# *Owosso Planning Commission*

RE: Special Planning Commission Meeting: February 2, 2016

# SITE PLAN FOR CARGILL ANIMAL NUTRITION PROJECT SPARTAN

**City of Owosso Planning Commission Staff Report**

REV: **C7**  
SHT# **7** OF **16**  
JOB No: 15C0179

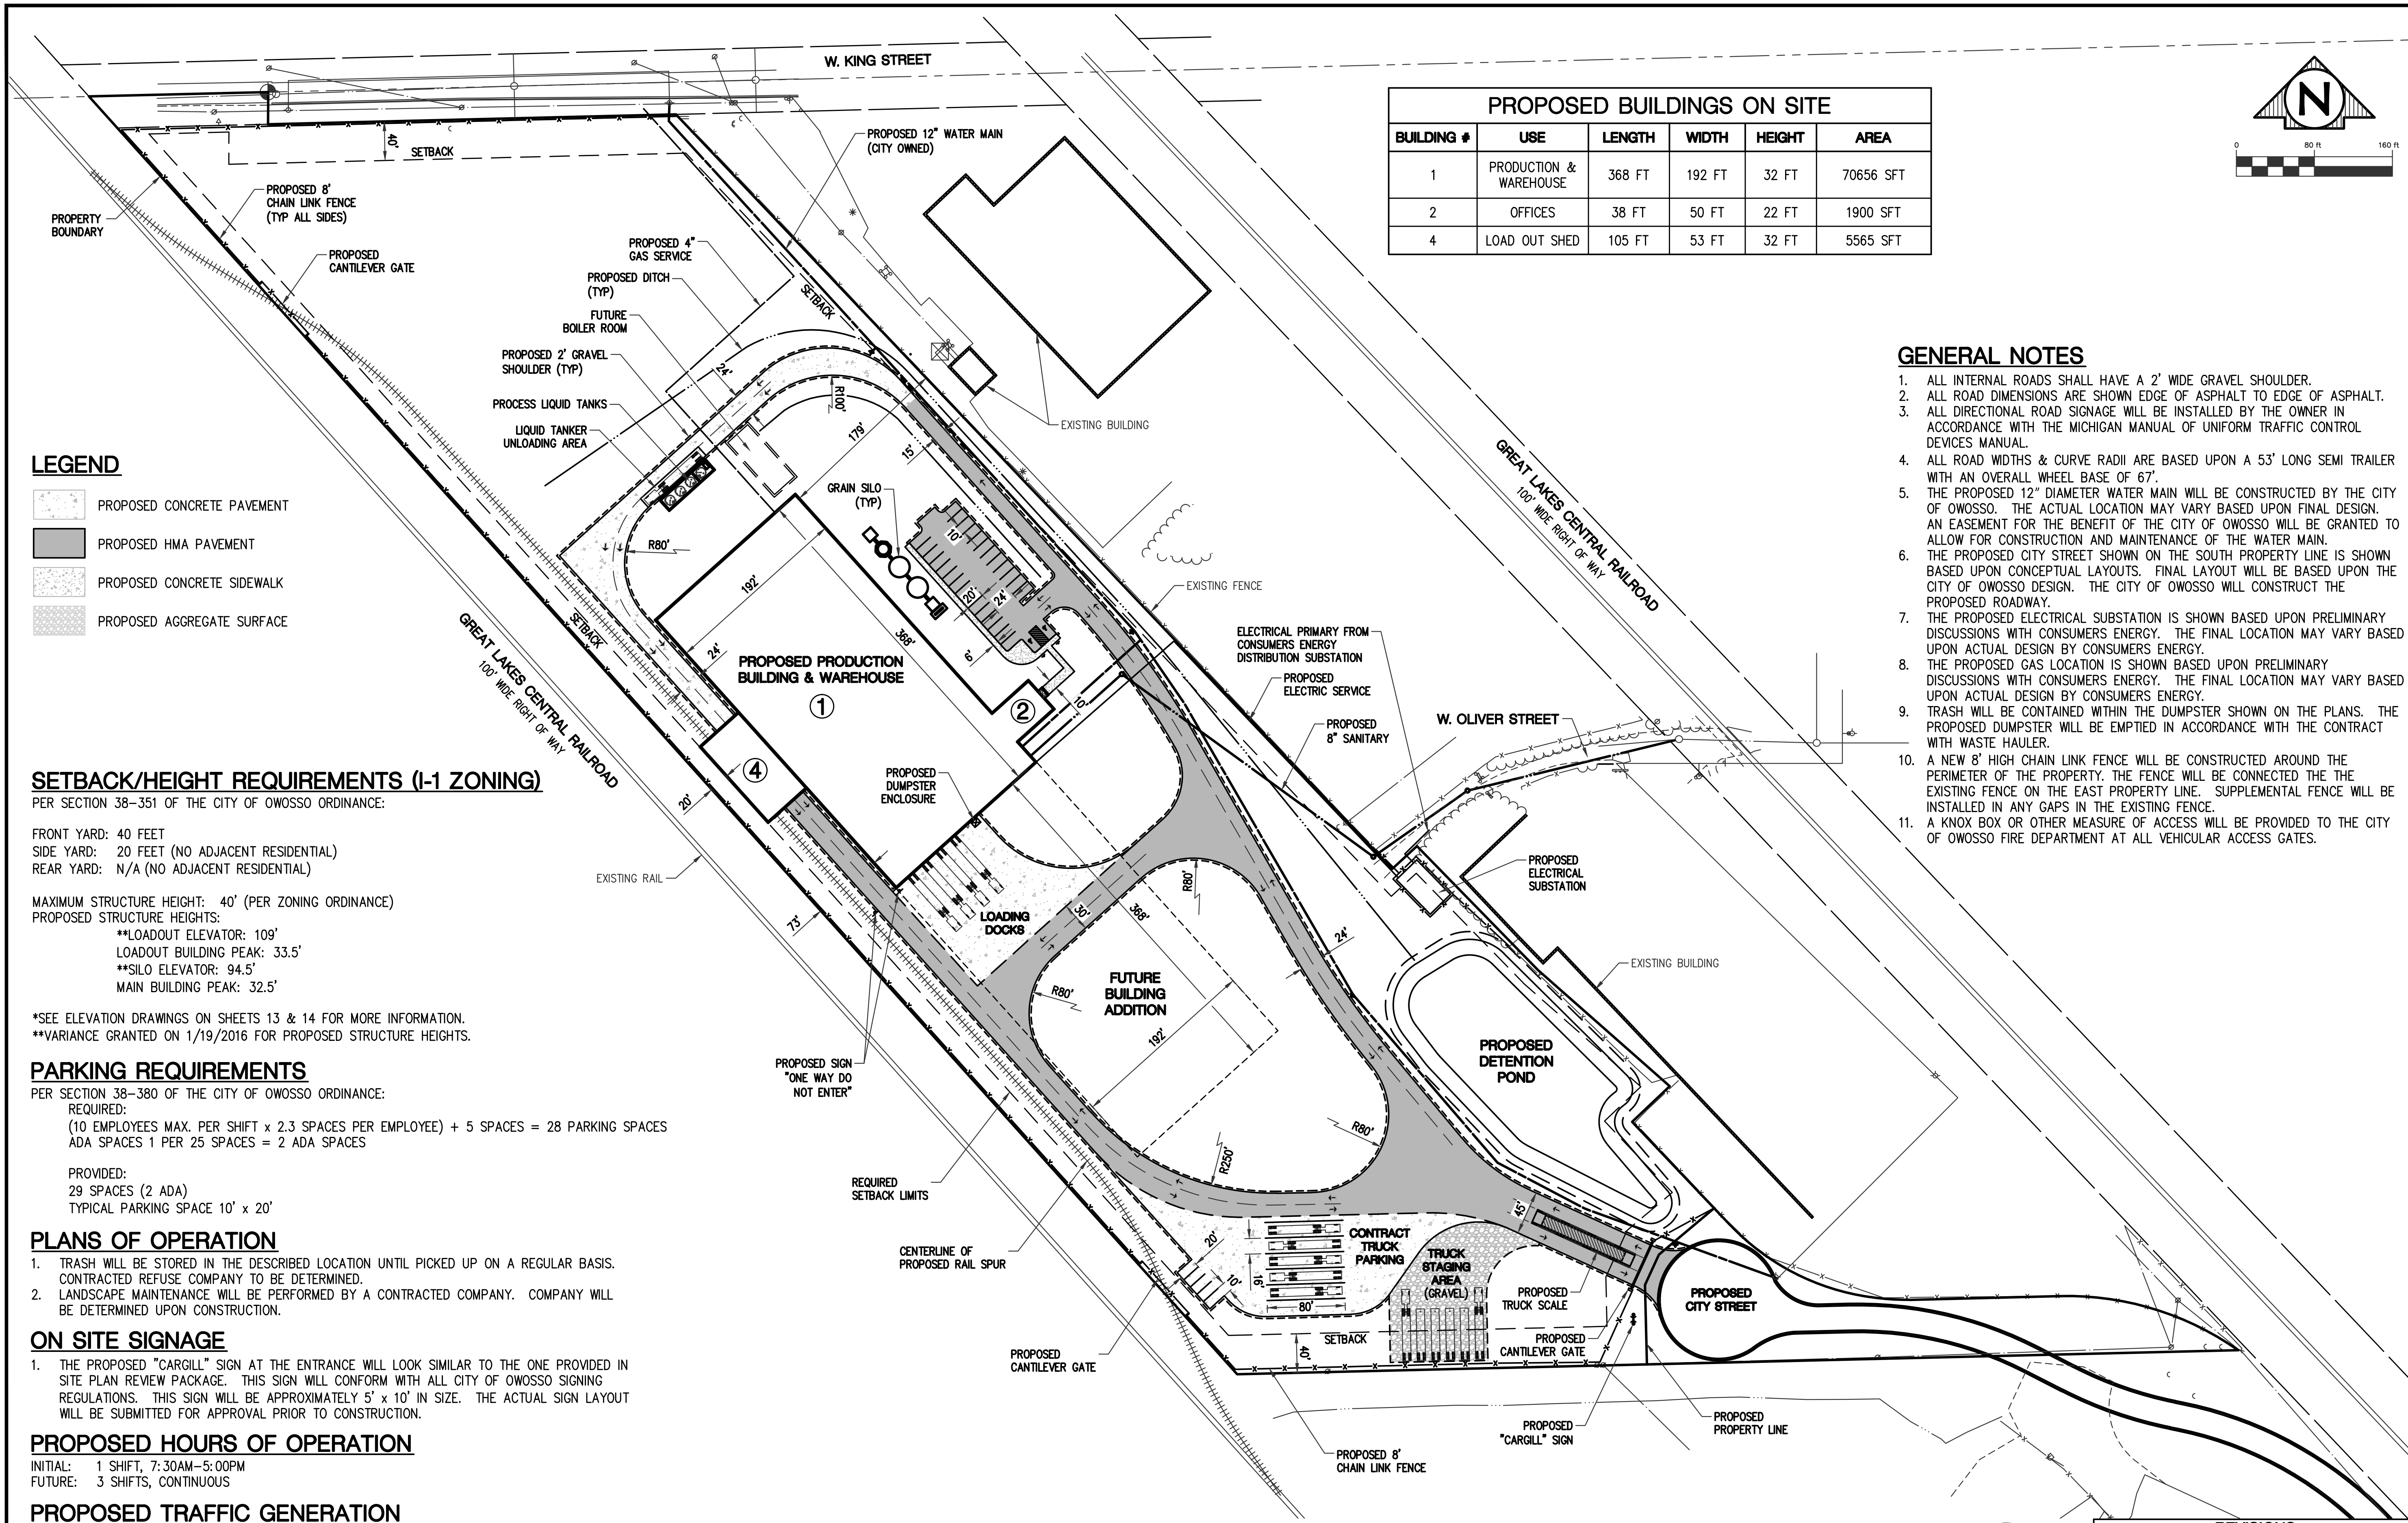
- b. I reviewed the HC Parking layout and it appears to satisfy city code.
6. Sheet C7, Site Plan:
  - a. Easement: Notes describe a 20' easement area for 'Drive and Roadway Purposes as Disclosed by Instrument Recorded in Liber 370, Page 140'. I have not read the easement and will trust the Engineer's review being accurate. The site plan shows a fence

- alongside some of the access area. The developer's engineer should review and lay comment that the developer's equipment may access the property without damage to the fence or encroachment from the 20' easement.

- b. Plan notes discuss wetland identification and information and are satisfactory.
  - c. I reviewed some water utility records with Glenn Chinavare. The records he has are different than what resides in Engineering. Glenn should clarify whether there are additional water utility pipes in the area near the access drive from W. Oliver Street. Pipe size should also be confirmed.

REV: **C8**  
 SHT# **8** OF **16**  
 JOB No: 15C0179

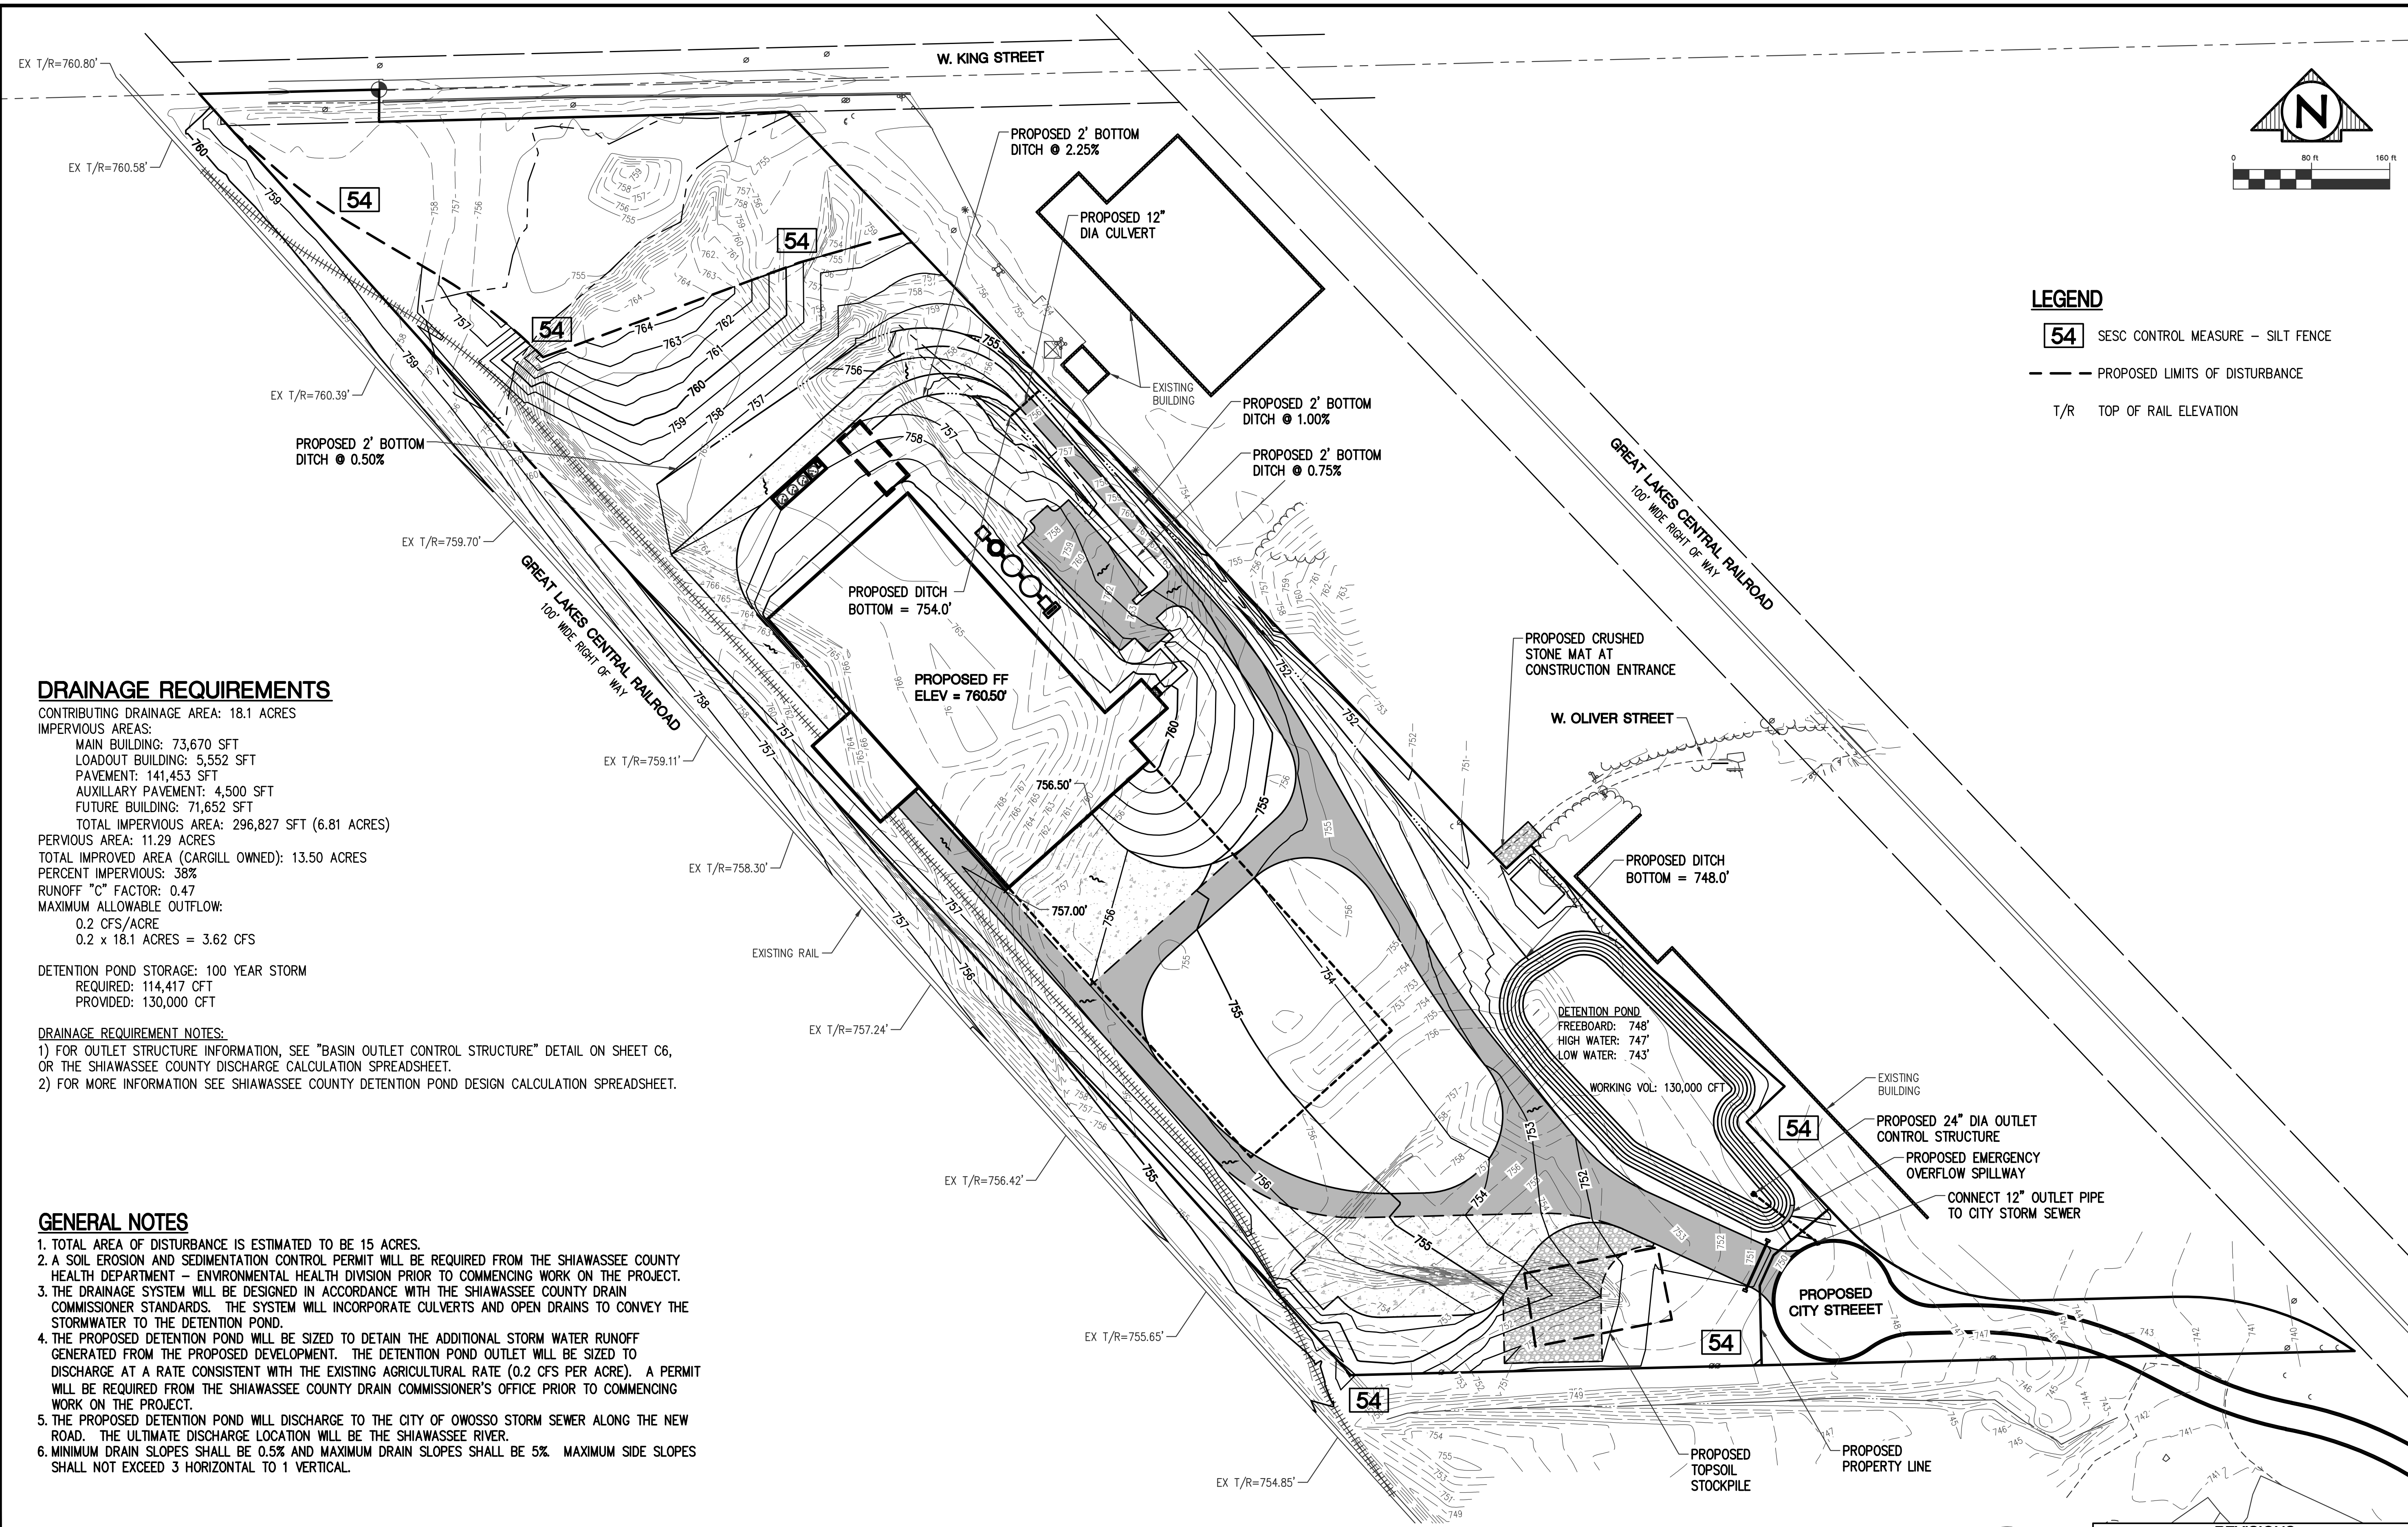
- d. All other notes and details on this page appear satisfactory.
7. Sheet C8, Site Plan:
- a. Plan note for Parking Requirements appears satisfactory, but should clarify that one of the HC spaces will be Van accessible. I assume the detail note on Sheet C6 applies.

- b. The proposed city street connection has been recently changed. The developer is aware the change will need to be included in the final plans. Same comment applies to Sheets C9 and C10.

1. The proposed 12" water main (Sheet C8) has been discussed with city administration. The present layout is contingent upon negotiations with Sonoco. The water main will be connected to existing water main at two (minimum) locations. Details for connections and fees will have to be worked out with city administration. Stubs for Internal connection locations are shown with little definition. Details for the connections should be provided in future plans. The water main's size is sufficient for servicing the facility.
